**Item 6.****Section 4.55 Application: 22 O'Riordan Street, Alexandria - D/2019/686/A**

File No.: D/2019/686/A

**Summary**

**Figure 13:** Proposed west elevation (O'Riordan Street), with the approved concept envelope outlined in blue solid line

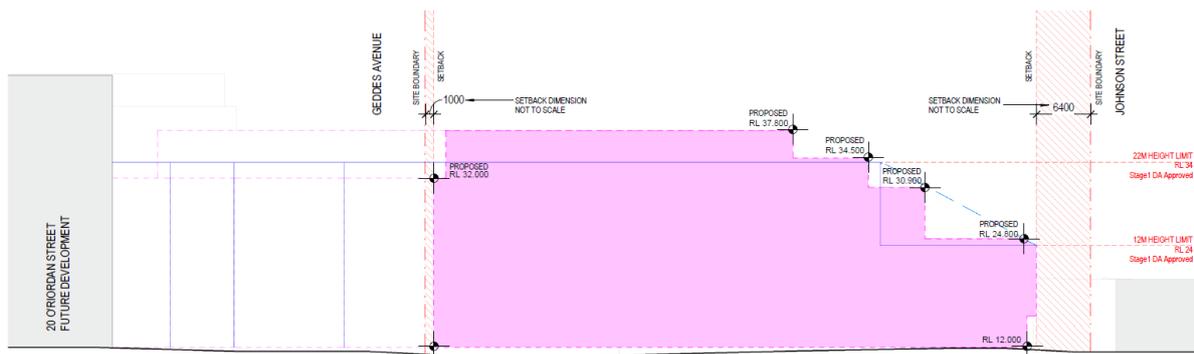
- (a) increase the building heights in the northern portion of the site to a maximum of 25.8m and in the southern portion to a maximum of 18.9m (the maximum height at the southern edge of the building envelope remains at 12m);

**Figure 15:** Proposed building footprint at ground level, with the approved footprint outlined in blue, showing a reduced setback to the eastern boundary

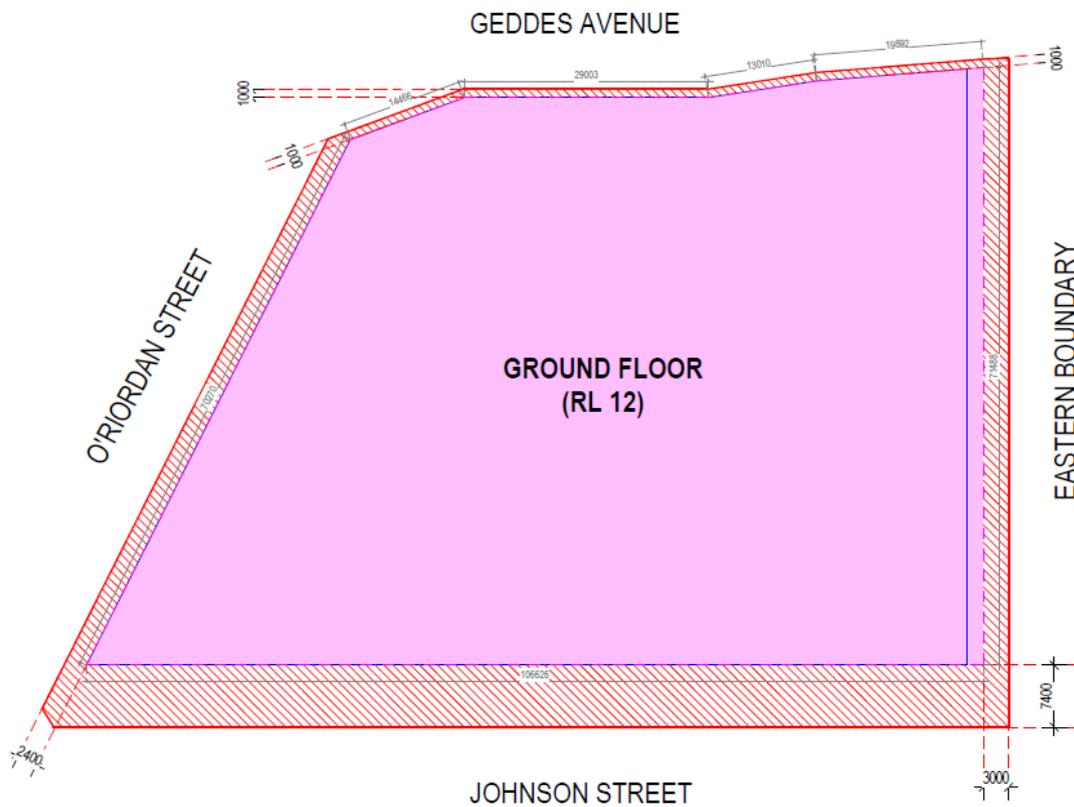
- (b) reduce the setback to the eastern side boundary from 5m to 3m and relocate the through site link to the middle of the site to be consistent with the winning design competition scheme;

**Figure 21:** O'Riordan Street elevation, with the maximum height outlined in red. This illustrates the lateral extension of the building into the 12m height zone and the increase in height to accommodate the rooftop plant area

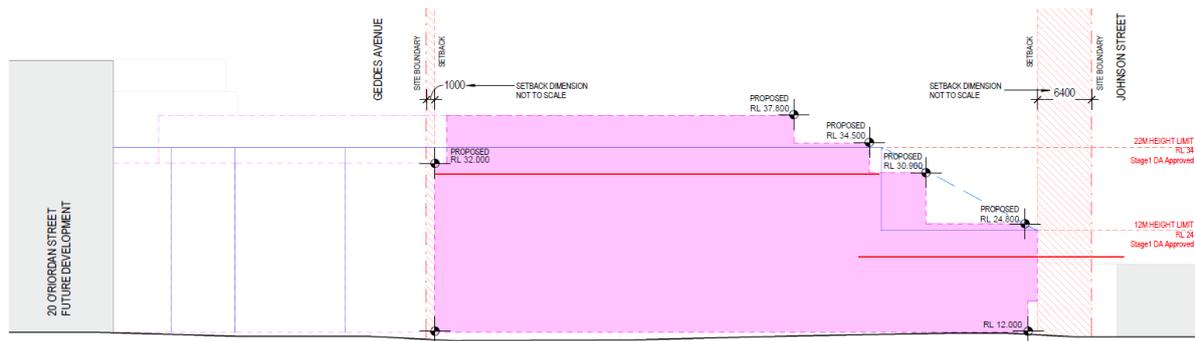
- (a) Northern portion - 25.8m, which represents a 3.8m or 17.27% variation. This is a consequence of two additional storeys to accommodate a centralised rooftop plant area that is set back from the northern boundary by approximately 7.4m and from the 'pre-dedication' southern boundary by approximately 32.2m; and

- (b) Southern portion - 18.9m, which represents a 6.9m or 57.5% variation. This is a consequence of a lateral extension into the 12m height zone on levels 3 and 4. The lateral extension is set back from the 'pre-dedication' southern boundary by approximately 18.2m, maintaining the maximum 12m height in the southern-most portion of the building envelope.

35. As a Section 4.55(2) modification, Clause 4.6 of Sydney LEP 2012 with regard to requesting a variation to the 'height of buildings' development standard does not apply. It is noted, however, that a detailed assessment under Clause 4.6 of the Sydney LEP 2012 has been carried out as part of D/2021529 for the detailed design, which also proposes a height variation.

Figure 23: Proposed deep soil area and relocated through site link

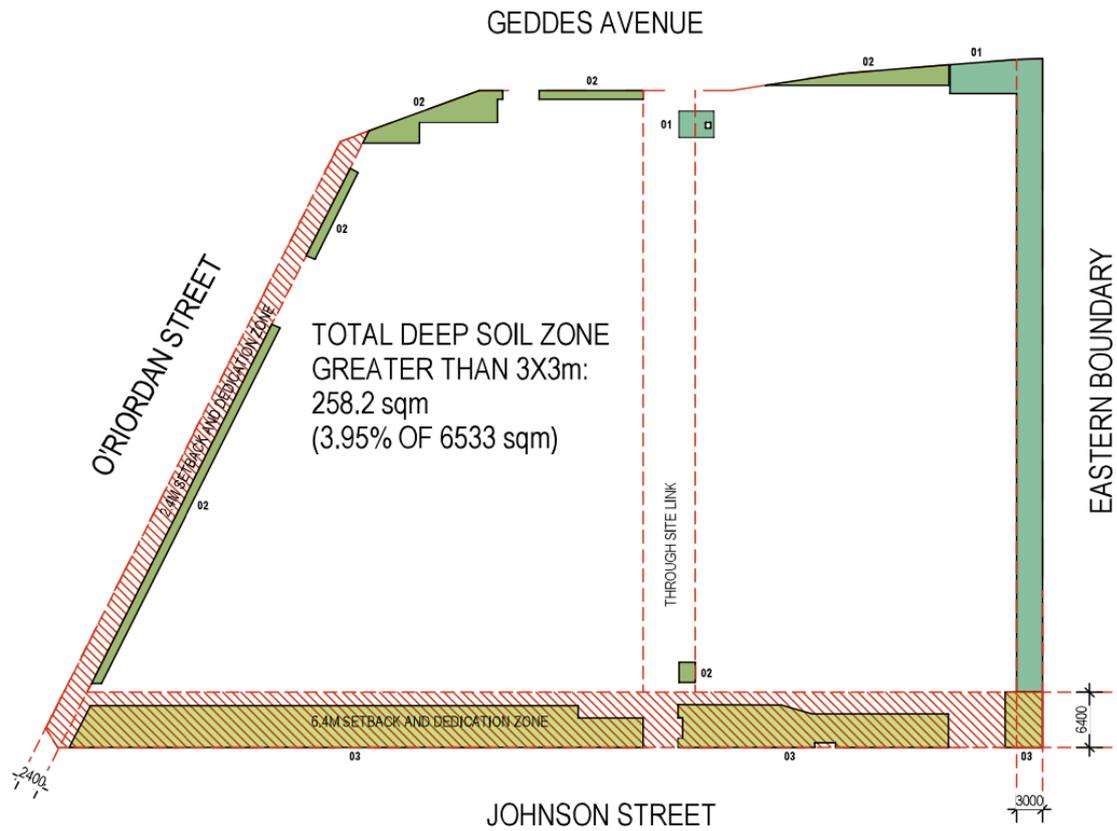
44. While this modification application originally proposes a reduction to 258.2m<sup>2</sup>, or 3.95% to align with the detailed design DA, the detailed design DA has been amended to provide a deep soil area of 288.4m<sup>2</sup>, or 4.4%, that is greater than 3m in dimension and encumbered by structures above or below as shown in Figure 24.

46. As the amended detailed design development application has demonstrated that a greater deep soil area can be provided, it is recommended that Condition 4(a)(i) be amended to require a minimum deep soil area of 288.4m<sup>2</sup> (4.4%) instead.
